#### TRAFFIC REGULATION ORDER (TRO) CONSULTATION

#### ARN8001MM - Bognor Regis: Upper Bognor Road

### (Felpham: Upper Bognor Road Amendment) and (Bognor Regis: London Road Consolidation) Order 2023

ARUN DISTRICT: FELPHAM AND BOGNOR REGIS
PROPOSED WAITING RESTRICTIONS (18.01.2023)

## PAGE 2 OF 2: PROPOSED CHANGES TO RESTRICTIONS (CIRCLED)

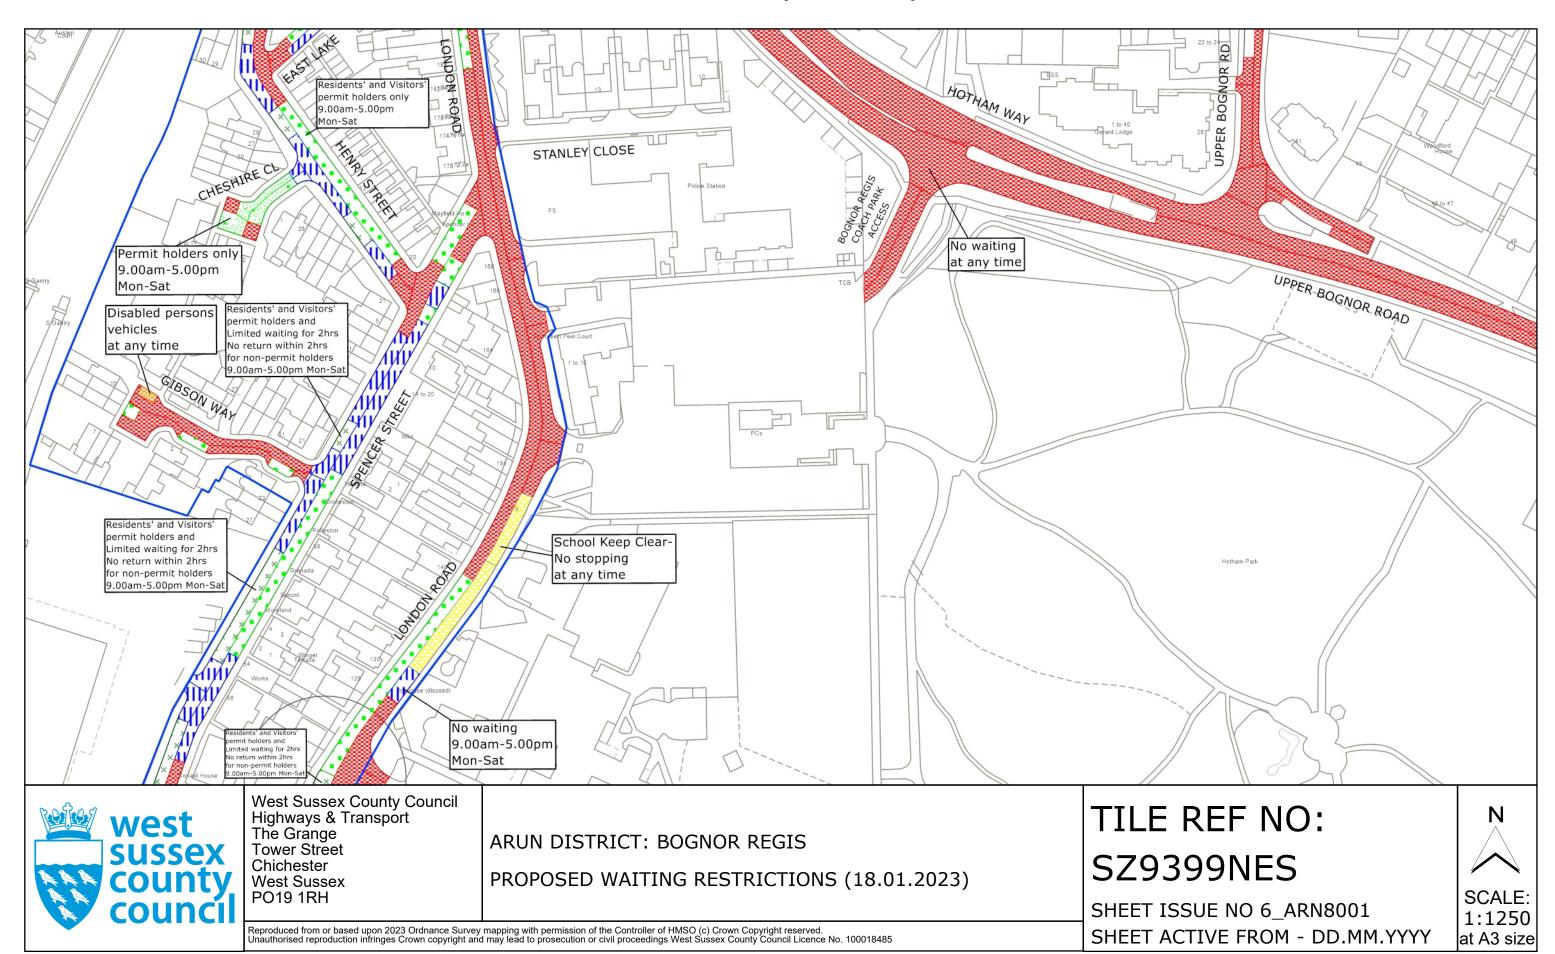
West Sussex County Council proposes to make a permanent Traffic Regulation Order that will prohibit waiting at any time (introduce double yellow lines) on the southern side of Upper Bognor Road in Felpham, from the end of the existing double yellow lines west of its junction with Sea Road, westwards by a distance of approximately 15 metres, to join with an existing bus stop marking.

It is reported that when vehicles park between the end of the existing double yellow lines and the bus stop on the southern side of Upper Bognor Road, buses are often unable to pull into the bus stop. When this occurs, buses obstruct the flow of traffic on Upper Bognor Road, inconveniencing traffic. Extending the existing double yellow lines by approximately 15 metres to remove the gap between the existing lines and the bus stop will resolve this problem and improve traffic flow on Upper Bognor Road.
